SUBJECT: DETERMINATION ON THE SUITABILITY OF SUPPLEMENTAL CHARACTERIZATION OF PROPOSED MAINTENANCE DREDGED MATERIAL FROM PORT OF SEATTLE TERMINAL 5 (CORPS APPLICATION: NWS-2009-1559-WRD) DREDGING PROJECT IN ELLIOTT BAY, WASHINGTON EVALUATED UNDER SECTION 404 OF THE CLEAN WATER ACT FOR OPEN-WATER DISPOSAL AT A DMMP NON-DISPERSIVE OPEN-WATER DISPOSAL SITE

- The following summary reflects the supplemental suitability determination on additional characterization conducted at Terminal 5, and consensus determination of the Dredged Material Management Program (DMMP) agencies (U.S. Army Corps of Engineers, Washington Departments of Ecology and Natural Resources, and the Environmental Protection Agency) on the suitability of an estimated **10,410 cy** of maintenance material at Terminal 5 evaluated for open-water unconfined disposal at the Elliott Bay non-dispersive open-water disposal site in Seattle, Washington.

Figure 1. T-5 proposed and actual sediment sampling locations

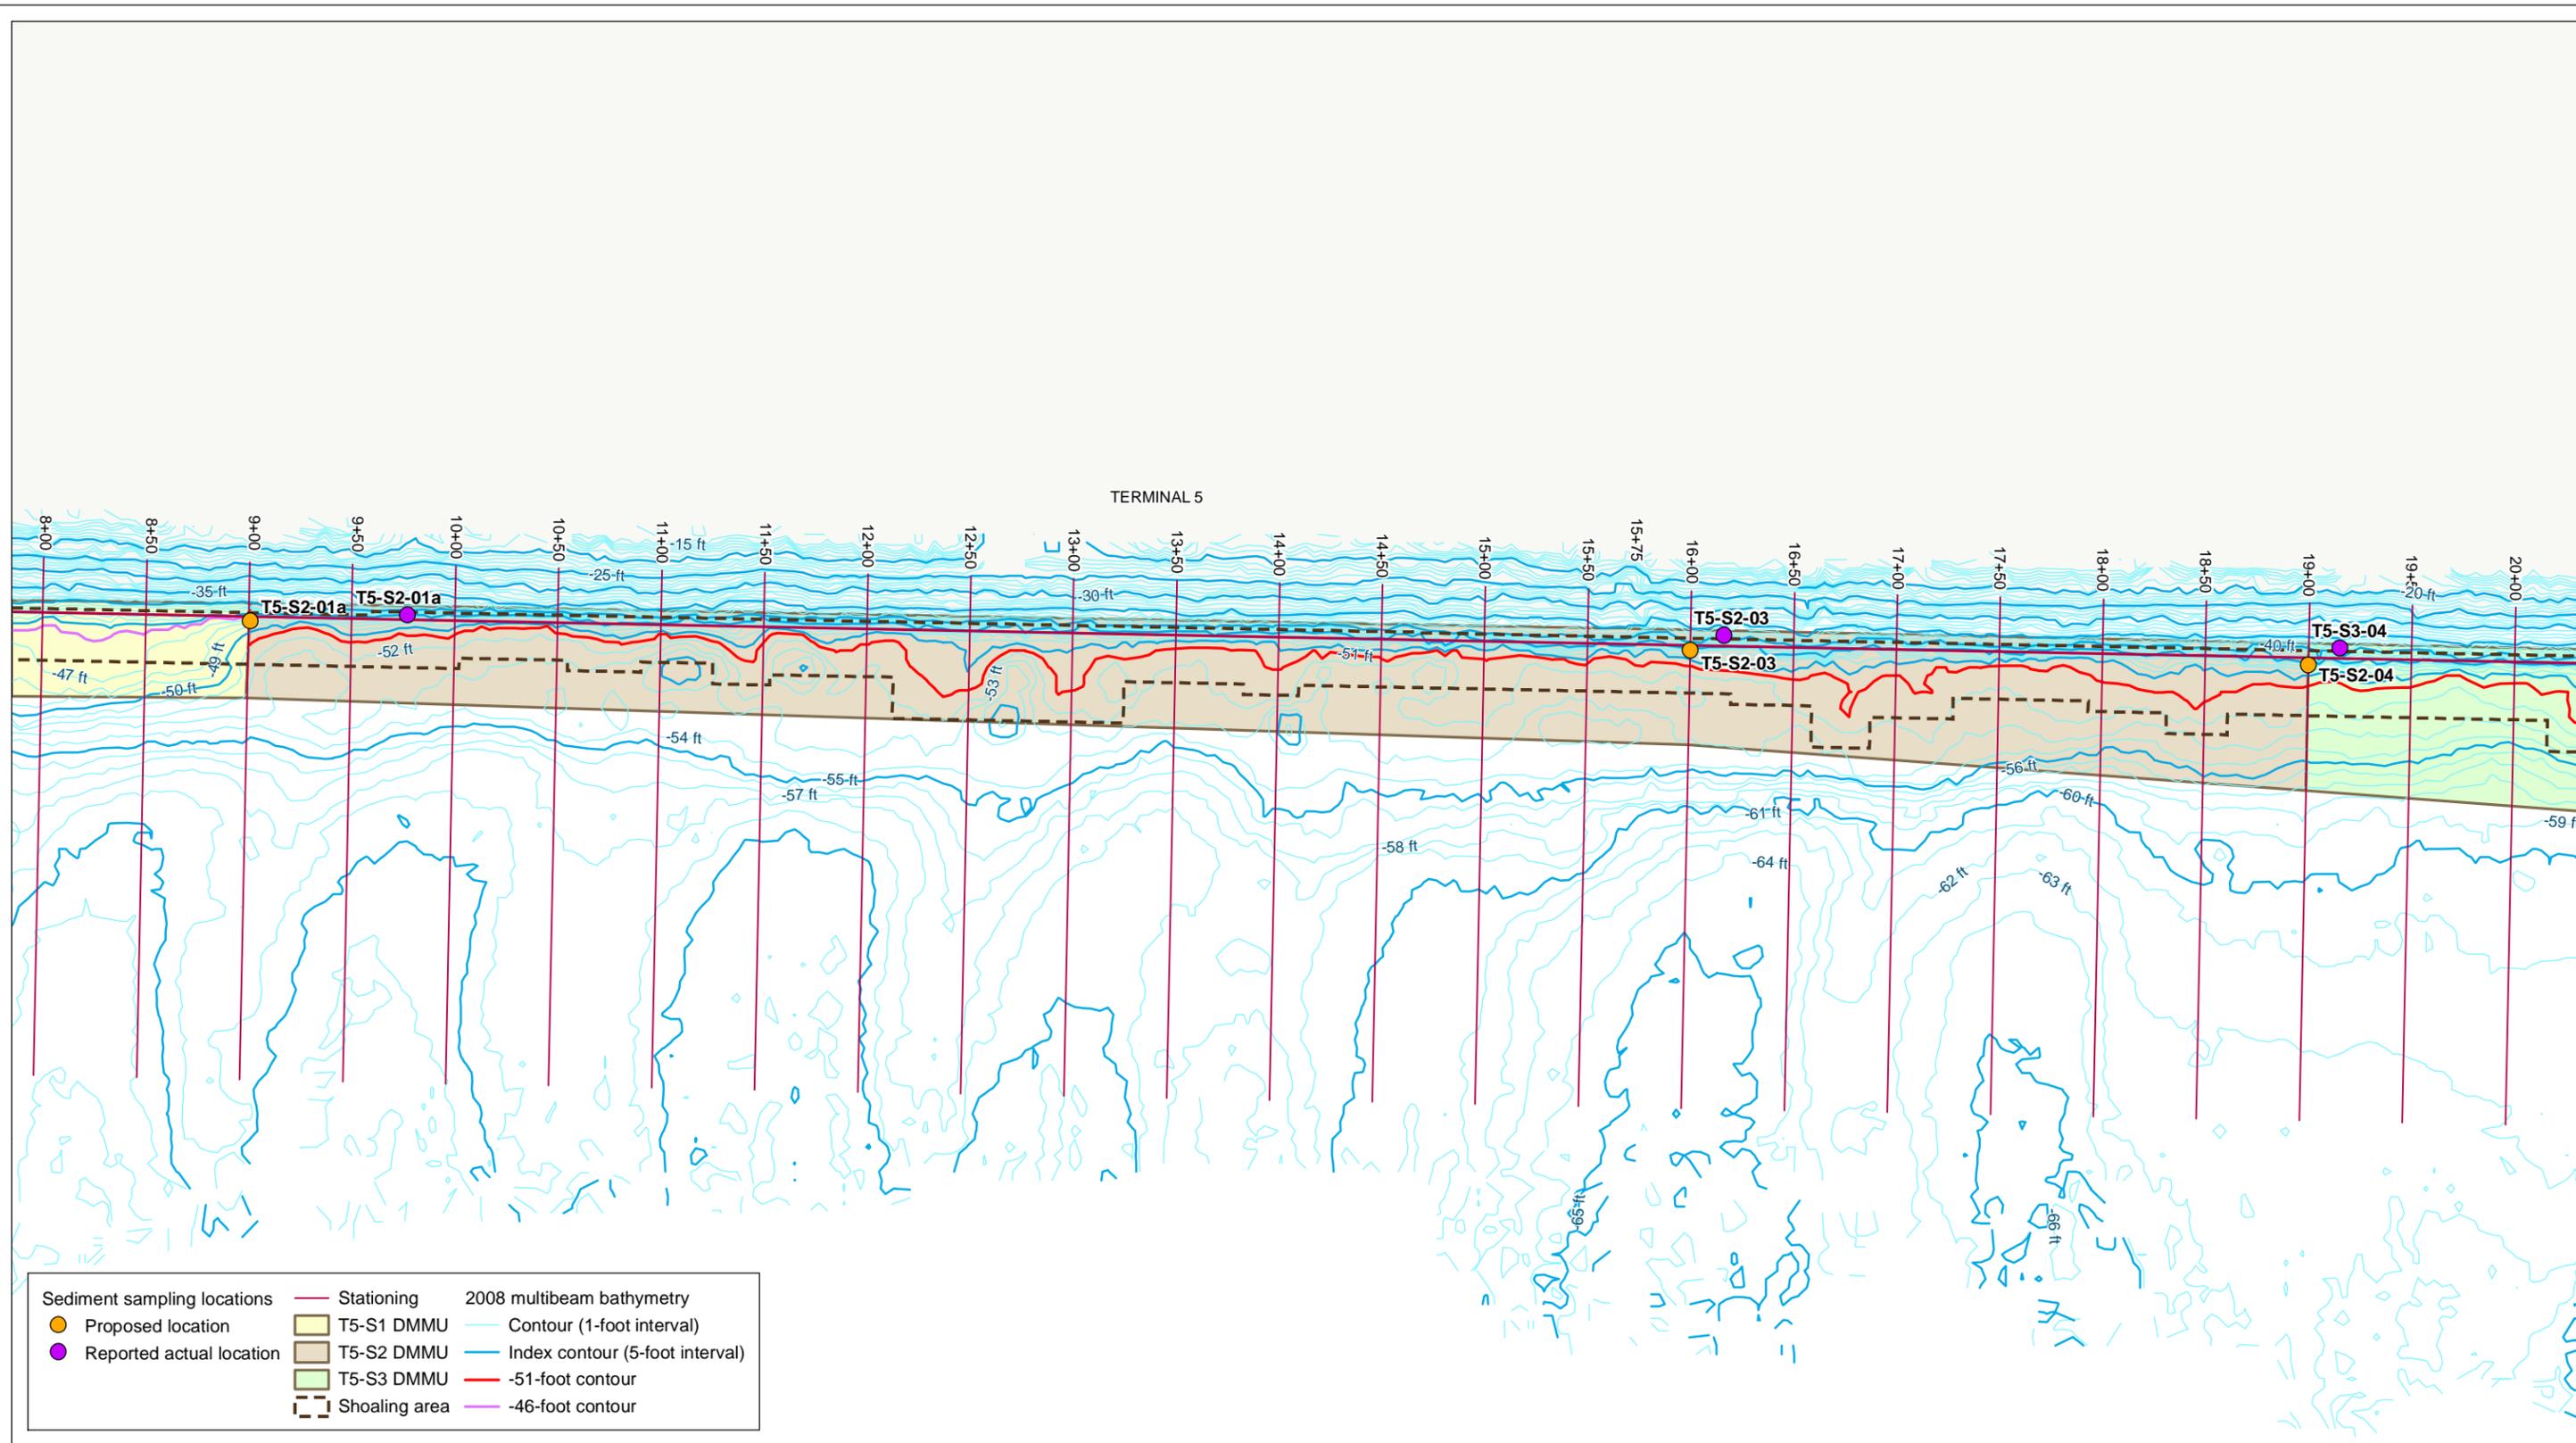
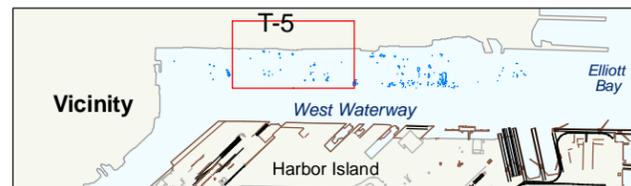
Z4, as depicted in **Table 3**, and **Figure 1**. The Supplemental SAP was submitted to DMMP agencies on September 2, 2009, and approved on September 10, 2009.

4. **Sampling.** The sampling was initiated and completed on September 24, 2009, and three samples from this High Ranked area were collected by vibracorer to characterize 1,210 cy of material in the expanded DMMU-2 footprint as depicted in **Table 4** and **Figure 1**. The two vibracore samples (S2-03 and S2-04) were composited for **DMMU-S3a** (S2-CS3), and the two archived z-samples (e.g. -52 ft to -53 ft MLLW) were analyzed as **DMMU-S2b** (S2-CS2) and the results of those analyses are summarized in **Tables 5** and **6**.
